**HUDSON RIVER PCBs REASSESSMENT RI/FS
RESPONSIVENESS SUMMARY FOR
VOLUME 2A: DATABASE REPORT
VOLUME 2B: PRELIMINARY MODEL CALIBRATION REPORT
VOLUME 2C: DATA EVALUATION AND INTERPRETATION REPORT**

DECEMBER 1998

**U.S. Environmental Protection Agency
Region II
and
U.S. Army Corps of Engineers
Kansas City District**

**TAMS Consultants, Inc.
Limno-Tech, Inc.
TetraTech, Inc.
Menzie-Cura & Associates, Inc.**

Figure 1. Ratio of Post-Release to Pre-Release Fish PCB Concentrations for Pumpkinseed (PKSD), Brown Bullhead (BB), and Largemouth Bass (LMB) in Thompson Island Pool (TIP) and Stillwater Pool (SW)

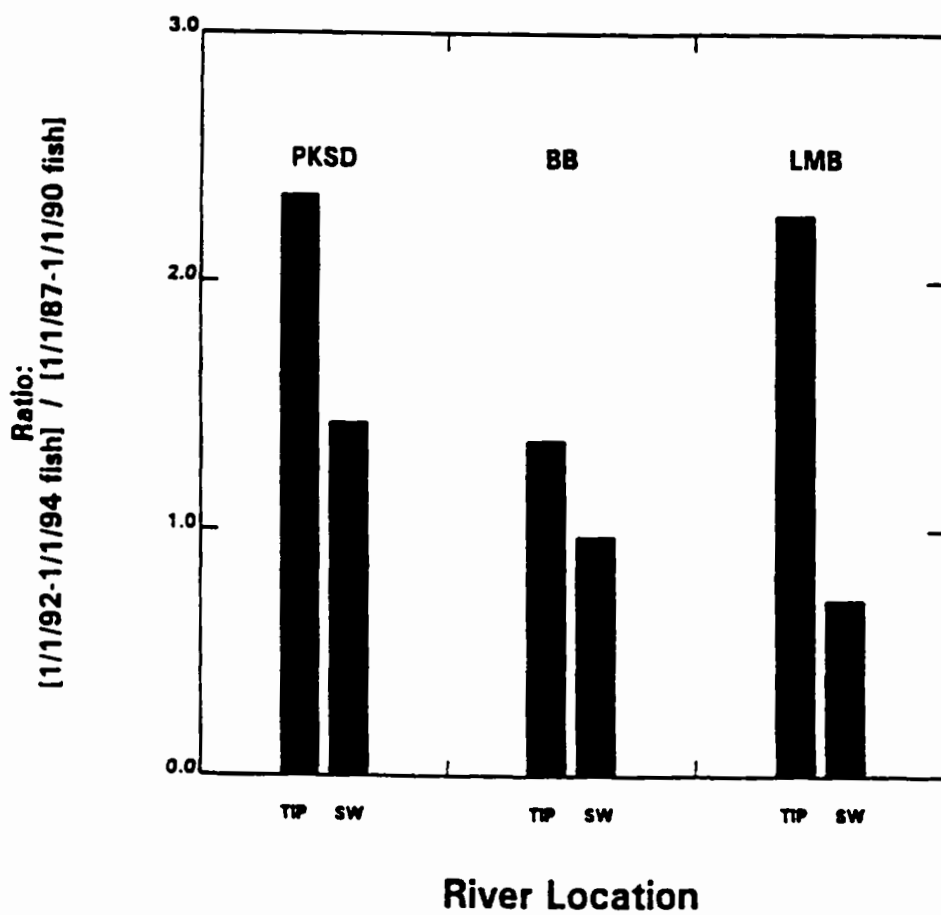
The impact of the changed sediment conditions may be evident in PCB concentrations in fish in the TIP. Comparisons of the changes in PCB content in brown bullhead, largemouth bass, and pumpkinseed in the TIP and at Stillwater following the 1991 and 1992 PCB releases shows a greater increase in the TIP, as shown in Figure 1. Given that water column concentrations were similar at the two locations, the impact in the TIP would only be greater if exposure concentrations in the sediments increased to a greater extent in the TIP than at Stillwater. The higher sediment concentrations might be reflected in the increased PCB levels in

Figure 2. TIP Sediment PCB Profile (left) with Projected 1991 Profiles with Sedimentation and Dechlorination Mechanisms (center & right).

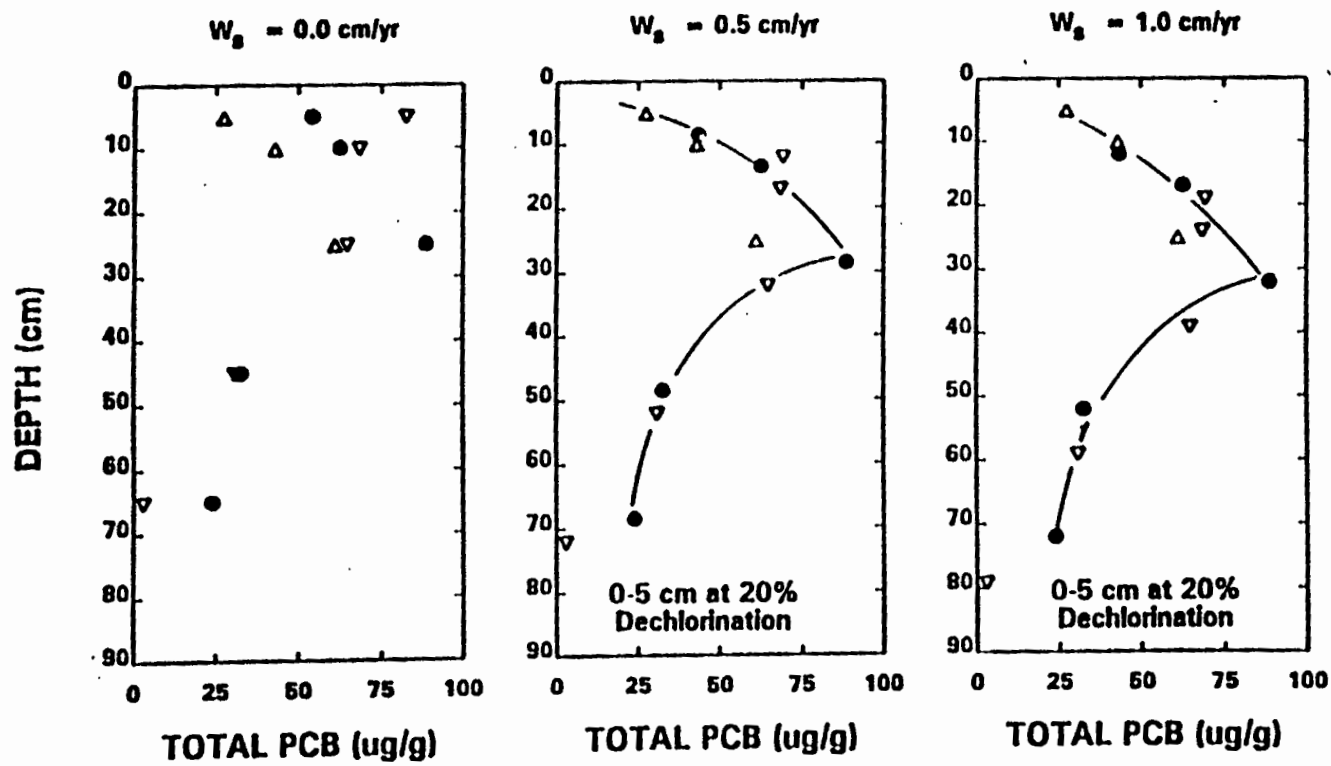
Long term burial as the dominant mechanism for loss of bioavailable PCBs is consistent with the available data reviewed to date. As an illustration, consider the vertical profiles of PCB concentrations in TIP sediment shown on Figure 2. Each panel shows measured

The middle and right panels of Figure 2 show these same sediment PCB profiles, but with the measured profiles modified in the following manner. First, the surficial (0-5 cm) concentrations are reduced by 20%, corresponding to an upper bound limit to the potential degradation of PCBs associated with anaerobic dechlorination processes. (This decrease is only applied to the mixed surface layer, since this is the only layer likely to have relatively recently deposited, undechlorinated PCBs). Second, the 1977 and the 1984 PCB profiles are shifted downward to correspond to the depth of burial that would occur from the time of sampling (1977 or 1984) to 1991. This vertical translation corresponds to a long term average net sedimentation rate of 0.5 cm/year on the middle panel and 1.0 cm/year on the right hand panel. With these modifications applied to the data, the blurred image described by the untranslated profiles on the left panel comes into focus and a relatively distinct, unified profile emerges. This is consistent with the conclusion that burial has simply moved the PCB profiles measured in 1977 and 1984

Figure 1. Areas of TIP with surface sediment PCB concentrations greater than 100 ppm.

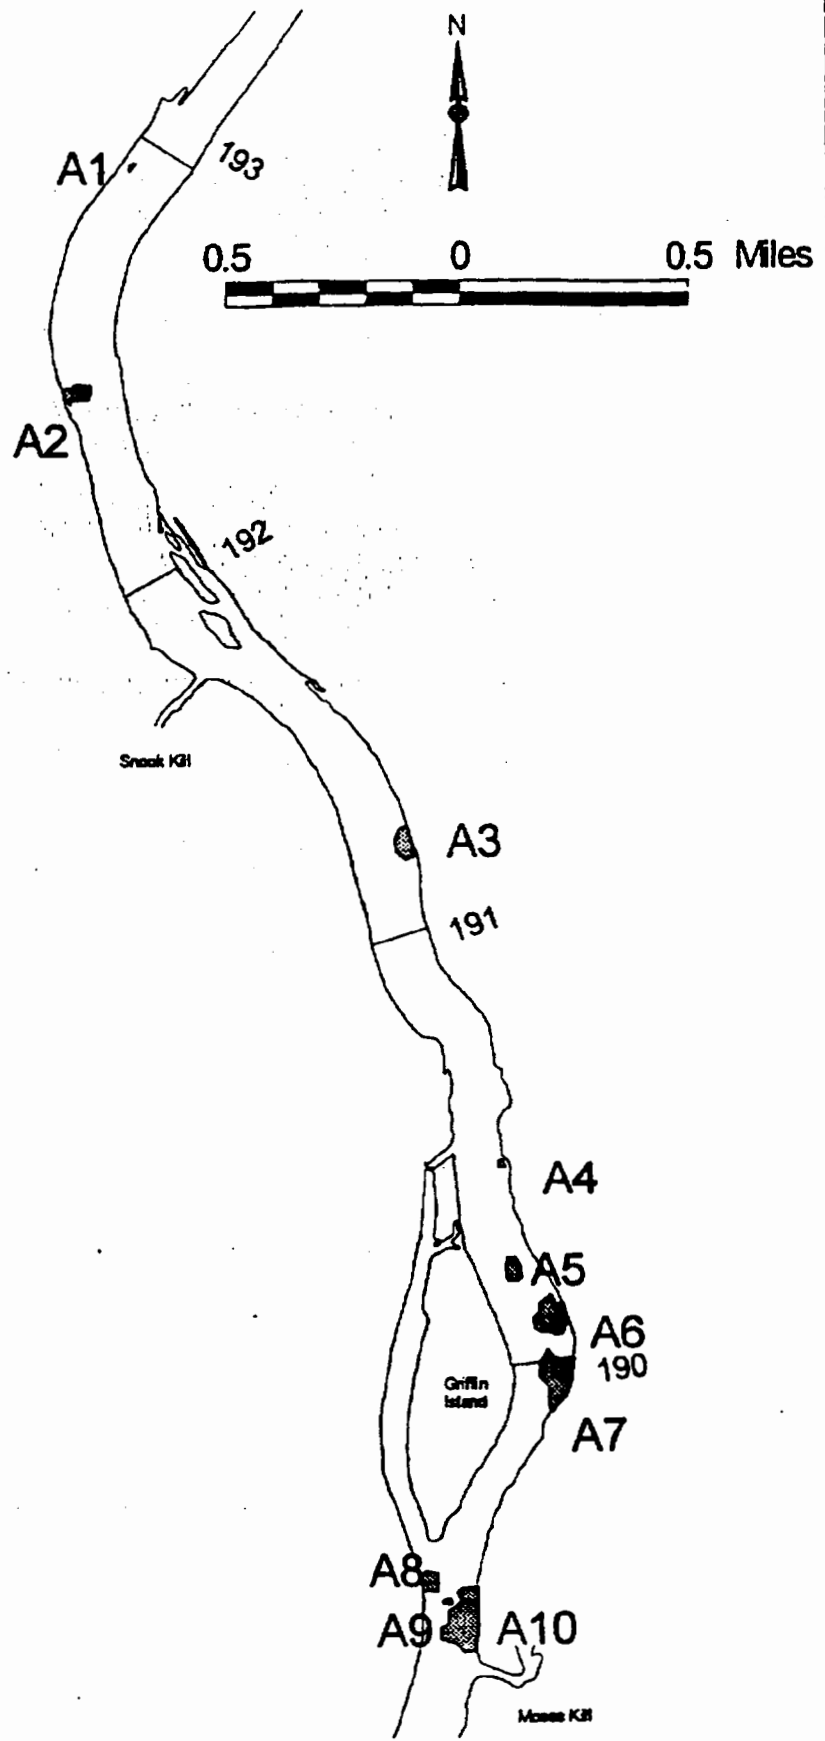
To evaluate whether the resuspension of PCBs from these deposits is plausible, we made an estimate of the surface area in the TIP containing PCB concentrations exceeding a conservative value of 100 ppm (A_{100}). The kriging analysis of the NYSDEC 1984 data presented in the Report provides an estimate of approximately 69,000 m² (Figure 1) of river bottom in the TIP where such deposits occur. The average vertical profile of PCBs within these areas was constructed using results from the 1984 NYSDEC cores (Figure 2). The average TIP loading increase over the 1993 and 1996 period would require an estimated loading from the sediments of 254 kg/yr since 1984 (W_{pcb}) (Table 2).

Figure 3. Annual sediment scour depths required to achieve water column concentrations necessary to maintain the TIP load.

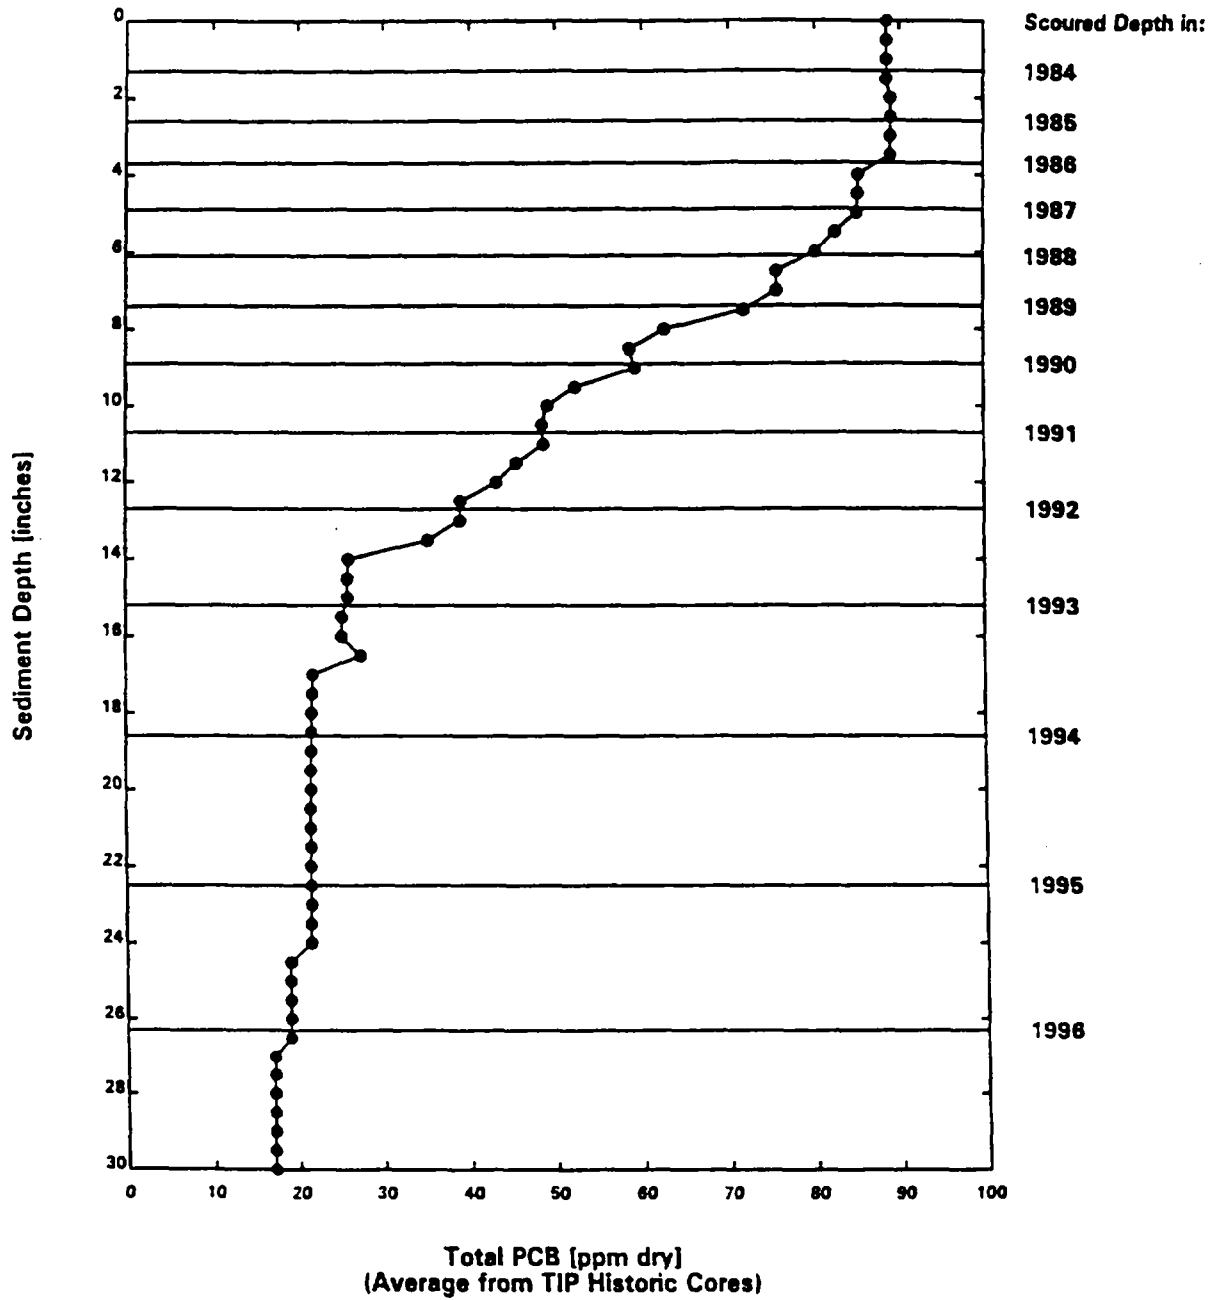
Figure 3 presents the depth of scour required on an annual basis to achieve the concentrations necessary to maintain the TID load. As can be seen, approximately 75 cm of sediments within these areas would have to have been eroded between 1984 and 1993 to provide the increased load across the TIP. EPA's analysis of its geophysical data indicates that such massive scour has not occurred. Indeed, these data indicate that the aged dechlorinated sediments are largely intact (report at 4-91).

Figure 4. Predicted cohesive sediment bed erosion in the TIP under low flow conditions.

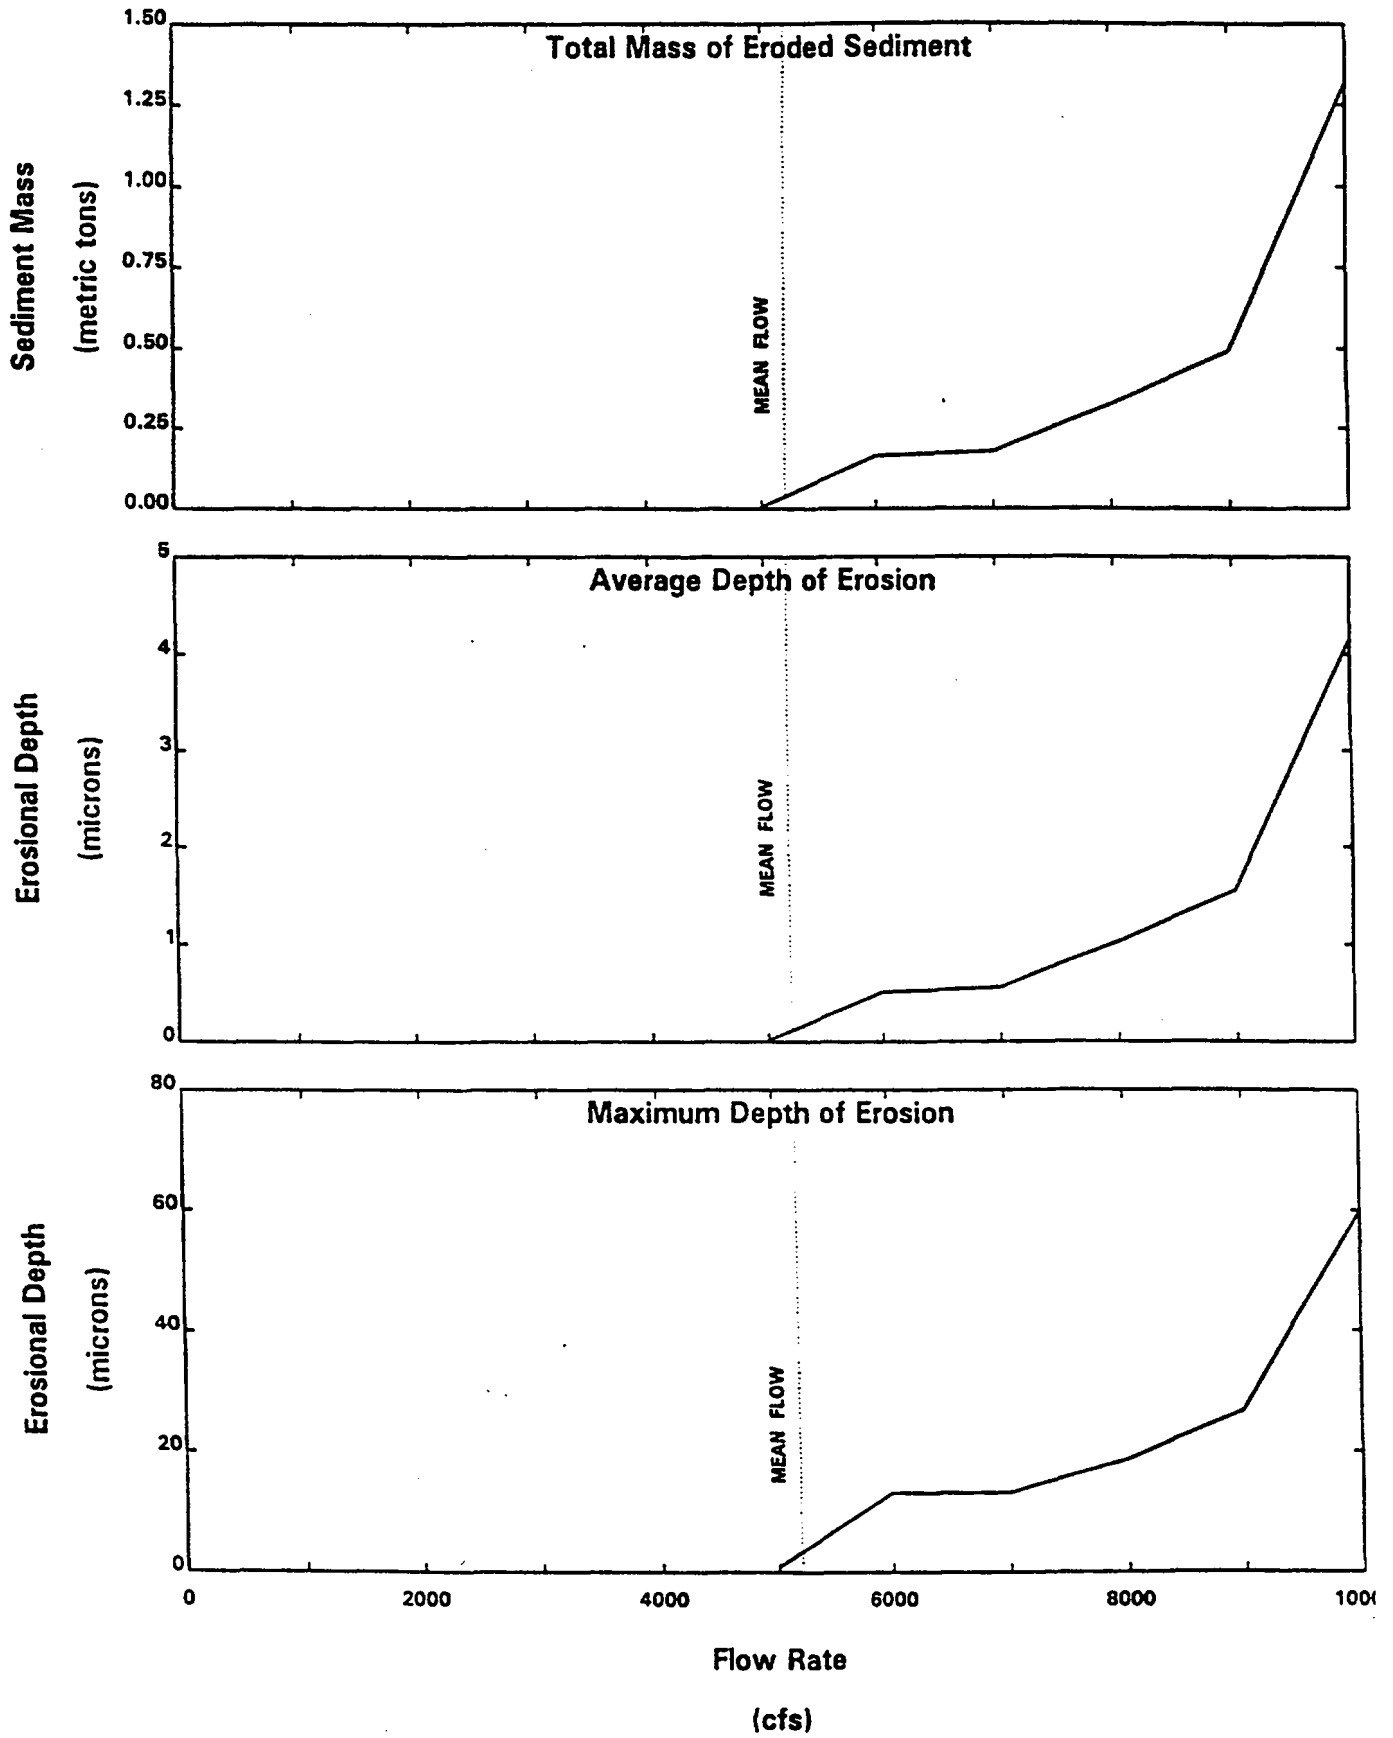
The sediment transport model was thus used to predict resuspension and deposition fluxes in the TIP under low flow conditions. Model simulations show that negligible gross resuspension of the cohesive sediment bed occurs for flow rates less than 5,000 cfs (Figure 4). To further investigate resuspension and deposition dynamics during low flow conditions, a simulation was performed for a constant flow rate of 3,200 cfs at Rogers Island. This flow rate corresponds to the mean value at Fort Edward during the EPA sampling periods in May and June of 1993. The data from this period were the primary basis for the low-flow resuspension hypothesis proposed in the Report. Model results show that net deposition, with only a minimal amount of resuspension, occurs in the TIP at this flow rate. The gross resuspension flux in the TIP is about 1,000 times smaller than the gross deposition flux, and the sediment that is eroded comes from a thin, surficial layer (approximately 10 μm thick) that is composed of loosely-consolidated, recently-deposited sediment (Figure 4). These results, combined with the observed resuspension properties of sediments, demonstrates the implausibility of the Report's hypothesis that relatively high gross deposition and resuspension rates, producing a small net change in water column solids load, caused the observed changes in PCB loading through the TIP during the 1993 low-flow periods.

Figure 7. Molar dechlorination product ratio versus fractional molecular weight change relative to Aroclor 1242.

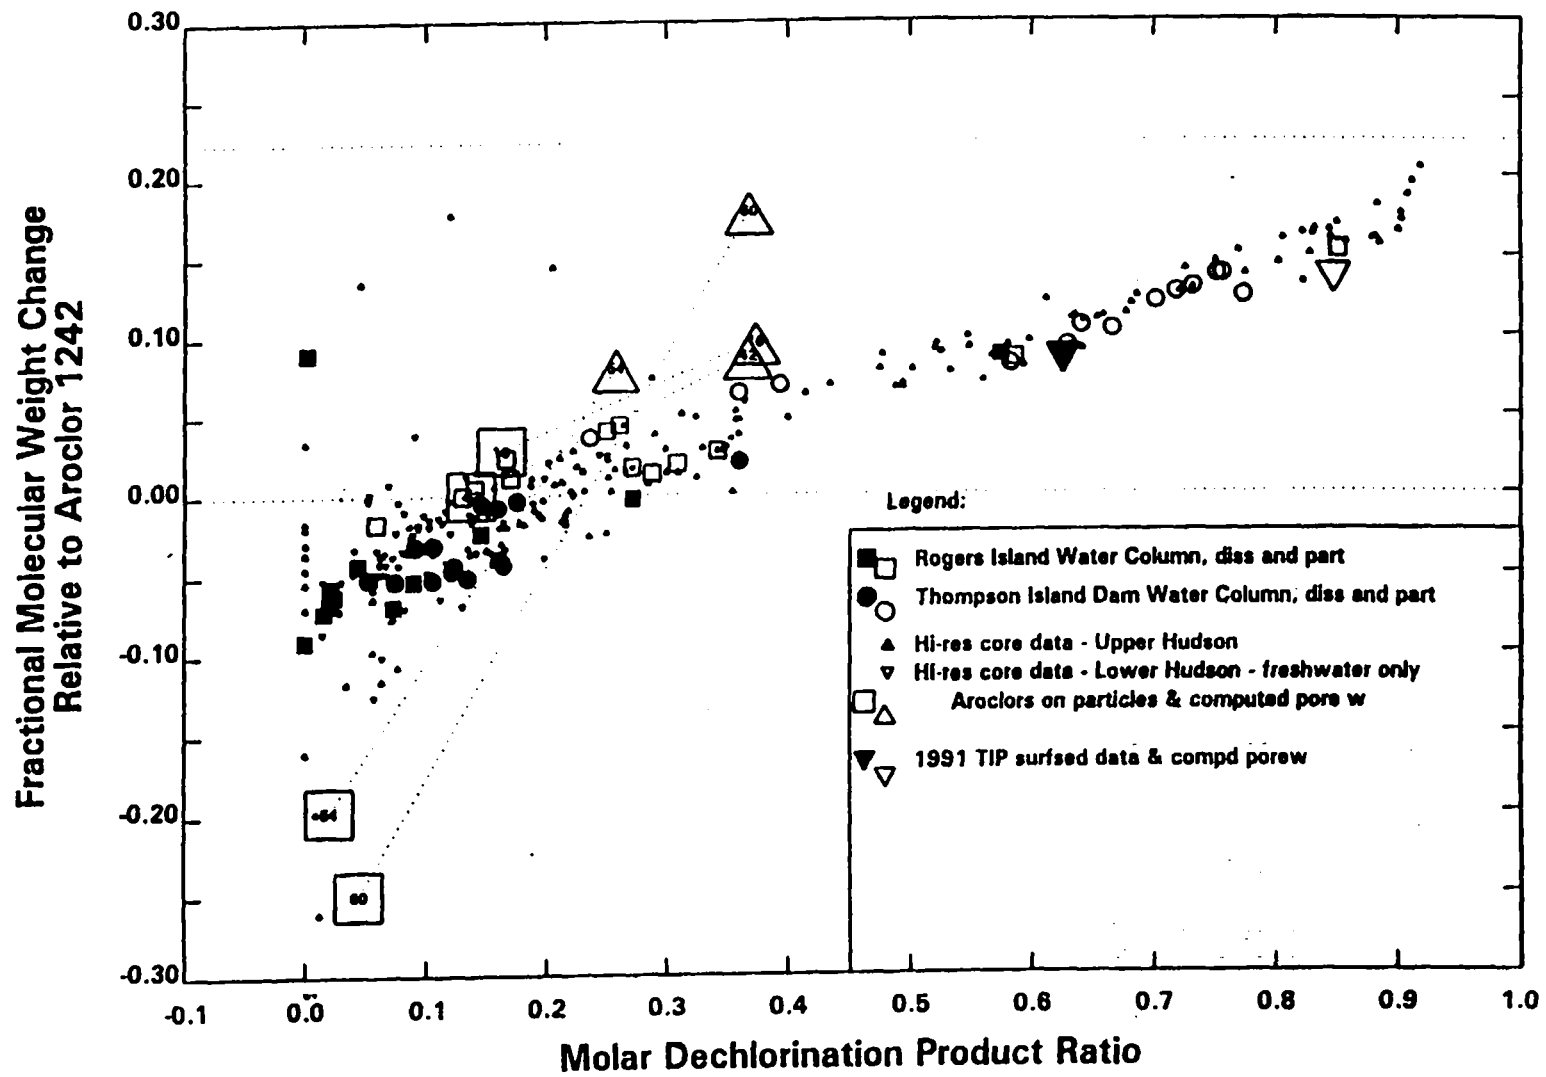
Index values for sediment samples, dissolved and particulate water column samples, and Aroclor standards are plotted in Figure 7, similar to the index plots provided in the Report. The index values of the particulate PCBs sampled at Rogers Island and at the TID (filled squares and circles on Figure 7) center on Aroclor 1242 (large open square symbol at the position (0.14,0.00), demonstrating that the source of these PCBs is unaltered or very slightly altered Aroclor 1242.

Partitioning of PCBs between the solid and the dissolved phases can alter the composition of PCBs and therefore the values of the indices. To demonstrate this, the original Aroclors (large open square symbols) and the dissolved material that would result from partitioning from original Aroclor sorbed to particulate material (large open triangles) are plotted on Figure 7. The
